HOWARD COUNTY HISTORIC PRESERVATION COMMISSION

November Minutes

Thursday, November 3, 2016; 7:00 p.m.

Figure 3 - Proposed gate

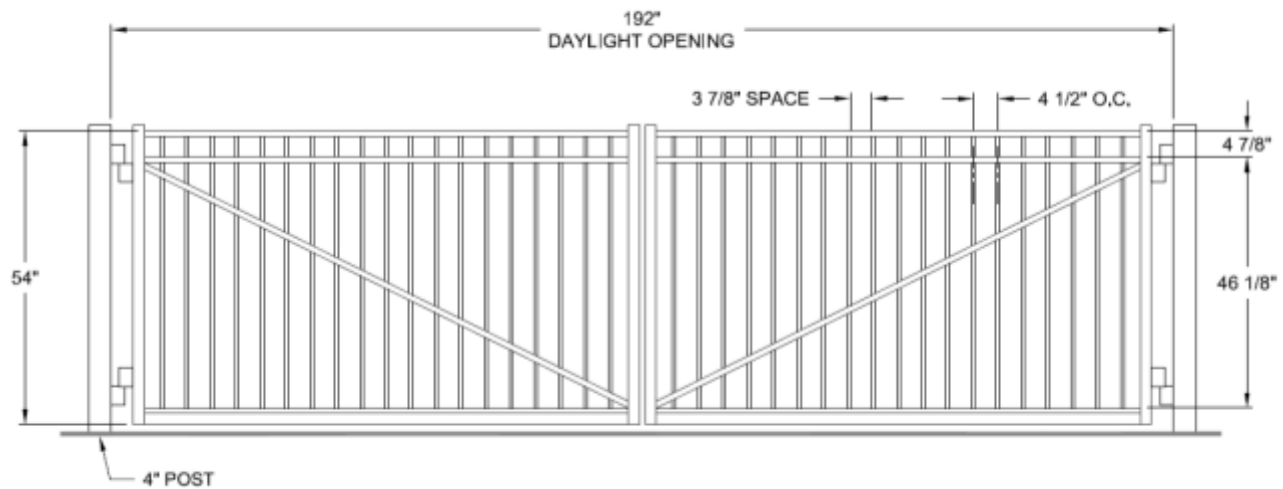
The black metal fence and gate will be a more historically appropriate fence than the existing chain link, as recommended by Chapter 9.D which states, “install open fencing generally not more than five feet high, of wood or dark metal.”

Staff Recommendation: Staff recommends Approval as submitted.

Figure 20 - Proposed gooseneck lighting

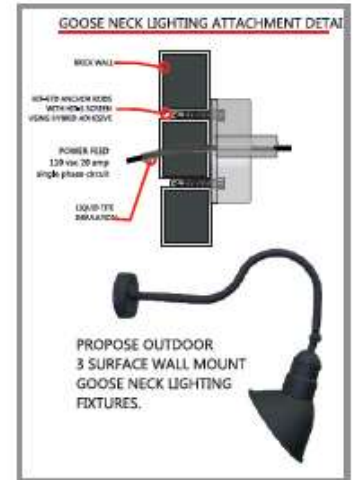
The proposed gooseneck lights comply with Chapter 11.A recommendations, “use indirect lighting or concealed light fixtures with concealed wiring to illuminate signs. If the light source will be visible, select a fixture compatible with the style of the building. Minimize glare by focusing the light on the sign.” The three gooseneck lights will be directed at the sign. The black metal fixtures also comply with Chapter 9.E recommendations, “use dark metal or a similar material.” The Guidelines recommend against using internally lit plastic signs, so the use of separate lighting fixtures as proposed complies with the Guidelines.

Staff Recommendation: Staff recommends Denial of internally lit signs. Staff recommends Approval of directory sign. Staff finds the flat mounted aluminum sign and gooseneck lights comply with the Guidelines, but recommends the sign be reduced in size and better placed on the building prior to Staff recommending approval.
